**Proposed Public Realm Improvement Works to Cathedral Street and Sackville Place
Dublin 1.
Plan Ref No. 4552/17**

LOCATION	Cathedral Street and Sackville Place, Dublin 1
APPLICANT	Environment & Transportation Dept. Civic Offices, Wood Quay, Dublin 8
DATE LODGED	18-Dec-2017
PLAN REF NO.	4552/17
ZONING	Z5
APPLICATION TYPE	LAW
DATE OF SITE INSPECTION	30/01/2018
SITE NOTICE	In order 30/01/2018
ZONING	Z5 – to consolidate and facilitate the development of the central area, and to identify, reinforce, strengthen and protect its civic design character and dignity'. The site is situated within the architectural conservation area (ACA) of O'Connell Street. The area of the site adjacent to O'Connell Street is also part of a conservation area.

Cathedral Street Proposed Plan

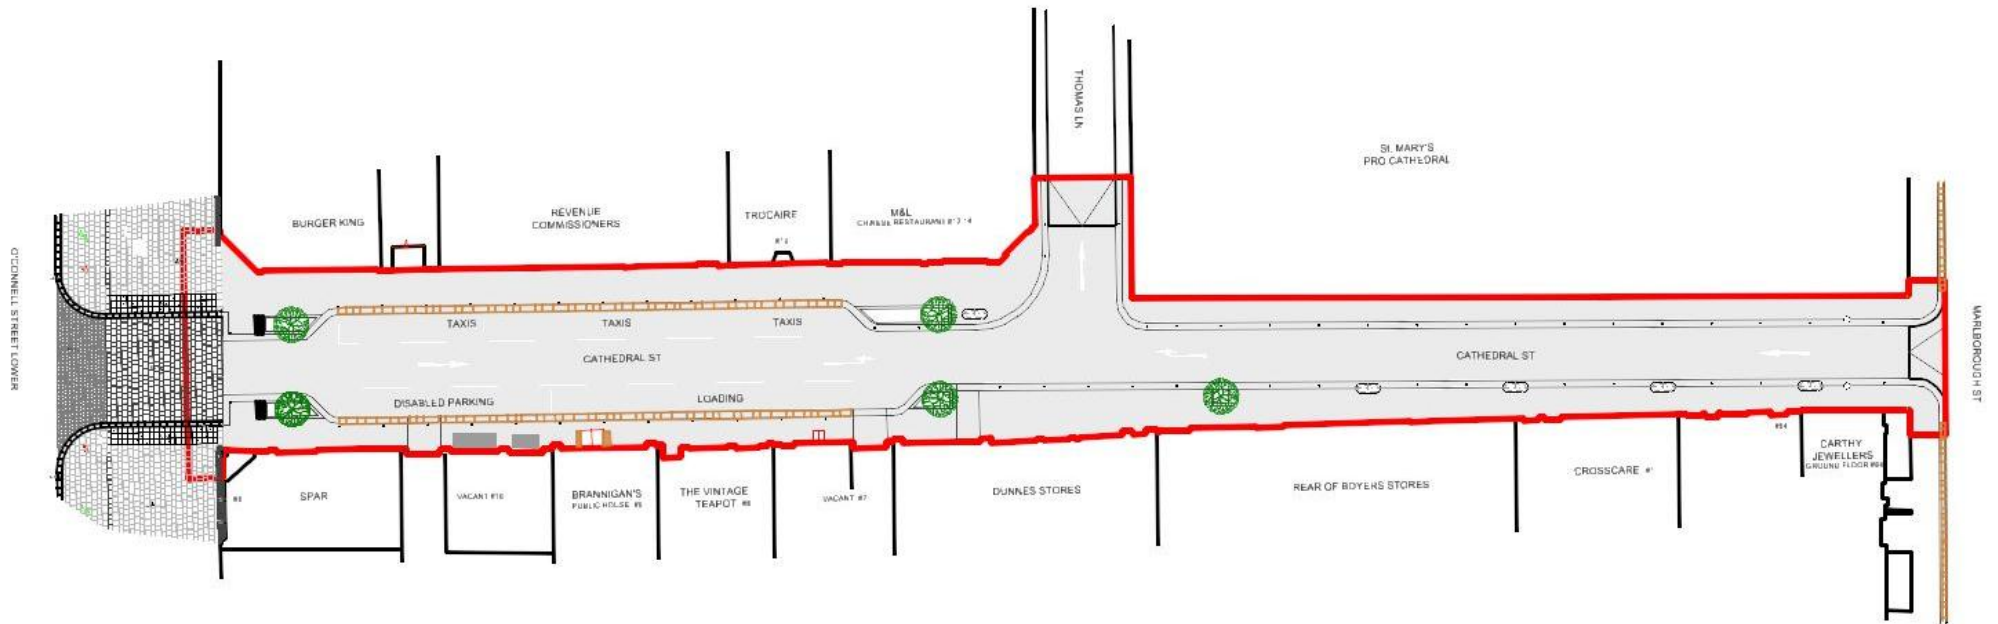
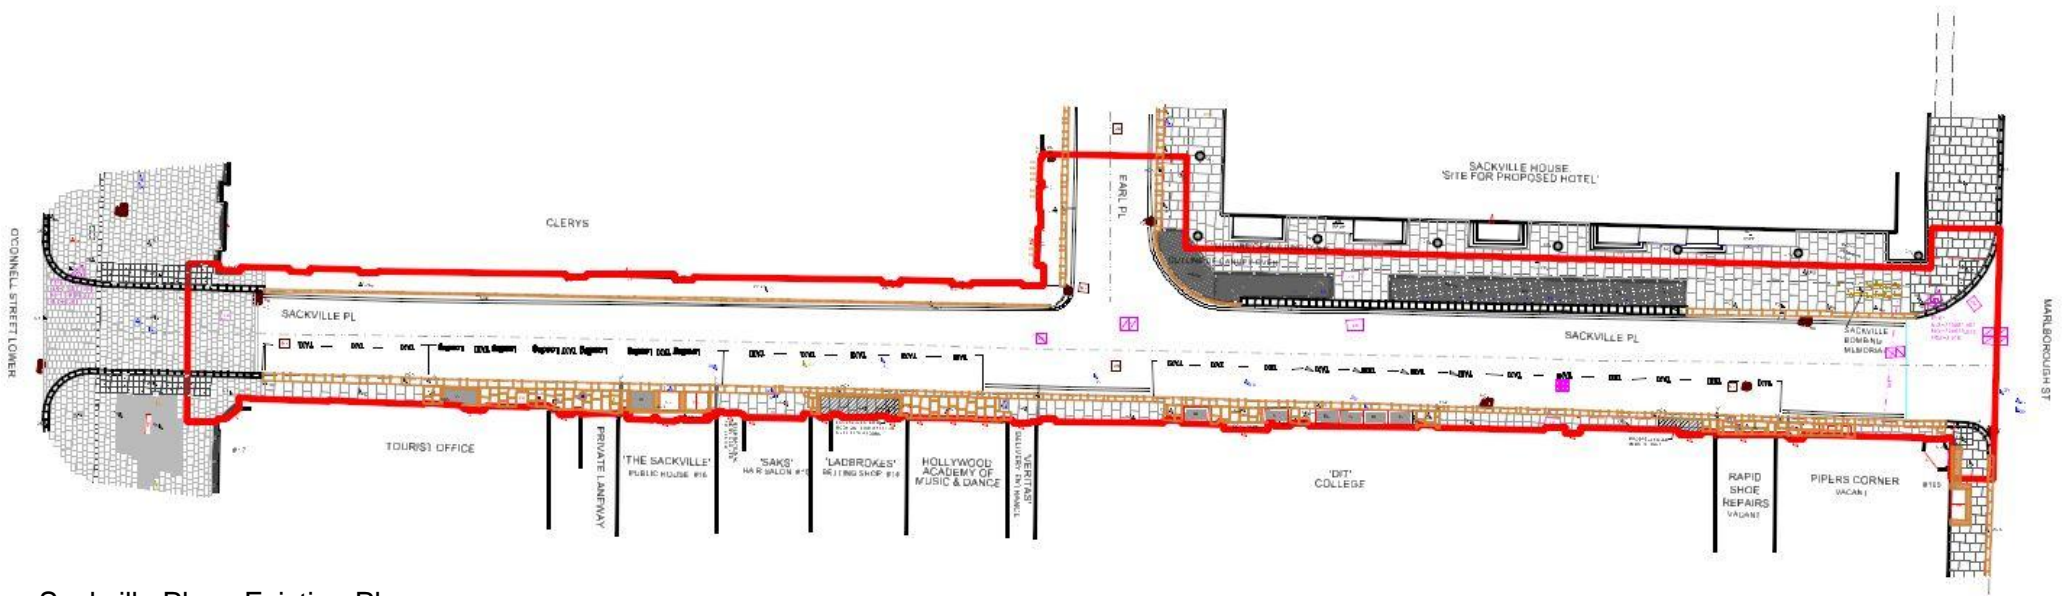
- National, architectural and social importance of the Pro-Cathedral with national religious ceremonies taking place - a proper standard of finishes would be required;

- Changes in level of paving abutting the walls of the Pro-Cathedral could result in water ingress to the vaults;
- Ongoing problem with litter on Cathedral Street due to bins overflowing;

- Bollards on Cathedral Street should not interfere with access to crypt of Pro-Cathedral and ramp access to the side;
- Could disabled parking be provided closer to ramp at side of Pro-Cathedral?

- Instead of two disabled parking spaces on the south side of Cathedral Street there should be one on each side;
- There should be no street furniture blocking the disabled parking spaces (note bicycle locked to pole blocking disabled space);

- Works should not impede public access to Revenue office on Cathedral Street;
- Need dished crossings at junctions of Cathedral Street with Marlborough Street and O'Connell Street with gradients no steeper than 1:12;

- Metal tactile paving should not be used;
- Granite paved surface on Cathedral Street should be non-slip and should have a colour differential between pavement and carriageway;

- Need sections through Cathedral Street showing footpath and basement retaining wall;

- Structural integrity of frame and retaining wall below footpath needs to be assessed;
- Construction details and section of new bollard foundations below footpath required;

- Proposed works welcome in principle but relocation of loading bays to southern side of Cathedral Street could have a negative impact on businesses on this side of the street;

- Proposed loading bays on south side of Cathedral Street would reduce visibility of businesses on this side of the street which depend on pedestrian footfall, while there is only one commercial premises on the north side of the street;

- Loading bays would impact on potential of two vacant units on south side of Cathedral Street to attract operators;
- Loading bays should be maintained in their current position or relocated to Thomas Lane;

It is proposed to provide a level surface along the two streets to ensure consistency with surface treatments in the central retail core, including the O'Connell Street, Henry Street/Mary Street and Grafton Street areas. It is proposed to delineate the carriageway from the footpath by means of drainage channels with bollards and street furniture. The western part of Cathedral Street (leading to O'Connell Street) will accommodate traffic throughout the day, with level surfaces delineated by road drainage channels and bollards. The design of the bollards will be subject to detailed design at a later stage, and this could incorporate measures to improve their visibility. It is noted that a 60mm high kerb could constitute a trip hazard and it is best practice to either have a higher kerb or to have no kerb at all. At signalled junctions, tactile paving would be red with colour differentiation used to delineate changes in the paving.

The proposed location of disabled parking, taxi parking and loading areas have been determined in accordance with best practice, including safety considerations. Delivery times can be agreed with the Traffic Advisory Group. In this regard it is noted that the default times for loading bays to be in operation are 7am to 7pm. It is noted that Cathedral Street is to be one-way, and that u-turns would therefore not be permitted. It is considered desirable to retain existing taxi parking in the vicinity, while consideration will be given to the issue of providing space to accommodate disabled taxi parking and space for access to such taxis. The works will be carried out in accordance with a traffic management plan in order to minimise disruption to businesses, stakeholders and the general public, with consultation in relation to the sequencing of the works. Provision can be made for a moratorium over the Christmas period, subject to consultation with the Traffic Advisory Group, and communication will be maintained with businesses in this regard. In the case of new developments which impact on the public realm (e.g. at Sackville House and Earl Place) it is not intended to carry out the proposed public realm works directly adjacent to these until they have been completed, due to the impact of the construction works on the surrounding public realm. It is also noted that the materials to be used in the public realm will be determined by those already in existence in the O'Connell Street area, with a view to ensuring consistency with the wider area, and proposals for Earl Place would be expected to be in keeping with this rather than vice versa. Materials to be used in Earl Place as part of the Clerys application will need to be subject to approval at compliance stage.

There needs to be a balance between respecting the setting of the Pro-Cathedral on the northern side of Cathedral Street and providing rear access and servicing to premises on the northern side of North Earl Street, which is a pedestrian street. It is noted that alterations to retail frontages to the streets is a matter for the owners/operators of the premises, subject to the necessary planning consents, but is outside the remit of this application. It is not envisaged that the proposed works would encroach on private property, while a street

Issues in relation to basements and waterproofing would be subject to detailed design. It is noted that existing light wells are privately owned. In cases where light wells are currently covered up, it is proposed to reinstate the paving with new paving.

Sackville Place Existing Plan

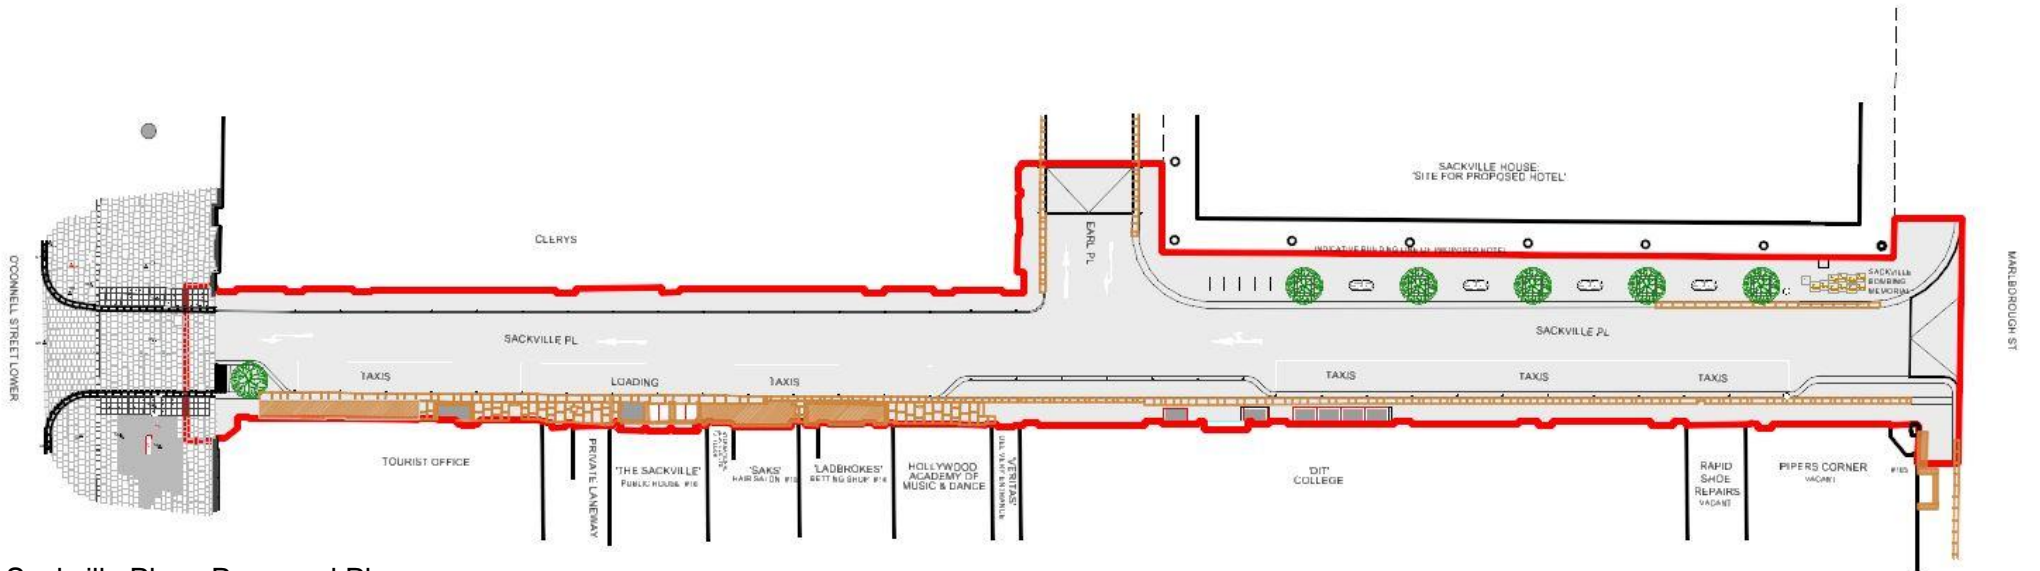
- Note permission for a 157-bedroom hotel at Sackville House on the northern side of Sackville Place, with works due to commence;
- Proposed public realm upgrade works are welcome and will help to create a high quality streetscape on Sackville Place;
- Sackville Place will act as an important linkage between O'Connell Street and the new Luas stop on Marlborough Street;
- No work sequence or programme of works included in the application;
- Need for liaison between applicant and project management of new hotel in relation to traffic management and sequencing of works;
- Works would need to be complete in advance of March 2019 when new hotel is due to open;
- Tree planting in front of hotel on Sackville Place should be low in height to avoid impacting on light to hotel bedrooms;
- Positioning of trees should not obstruct key views of signage for hotel and adjacent cafe;

- Memorial plaque on footpath of Sackville Place should be appropriately situated in relation to the hotel and this should be subject to discussion;
- Works to Sackville Place should be co-ordinated with works at Sackville House (Reg. Ref. 3919/15);

- Footpath width should be 2m to allow two wheelchairs to pass one another; where this is not the case passing places should be provided;
- Location of bicycle stand, seating, planting and memorial stone on Sackville Place should not compromise the footpath width required for wheelchair users – seating and planting could be clustered rather than occupying the length of the street;

- Sackville memorial should allow for a minimum footpath width of 1.5m;
- Sackville Place is too narrow to accommodate a bicycle stand;
- If kerbs are provided dished access points will be required;

- Bollards should be 1m high, 250mm wide, should be differentiated in colour and should not be linked by chains;
- A crossing point should be provided on Sackville Place;

- Taxi rank should not be retained on Sackville Place due to narrow width of street;
- Projecting footpath on southern side of Sackville Place opposite Earl Place should be removed as it restricts delivery vehicles;

- Two-way traffic between Earl Place and Marlborough Street should be retained to allow delivery vehicles to exit Sackville Place;
- Existing daytime loading bay on Sackville Place should be retained;

- c) The exact location of the reinstated memorial stone on Sackville Place.
2. The exact location and species of trees shall be the subject of agreement with the Parks and Landscape Services Division of Dublin City Council.

3. A taxi parking space, suitable for use by wheelchair accessible taxis, shall be provided at a location to be agreed with the Environment and Transportation Department.
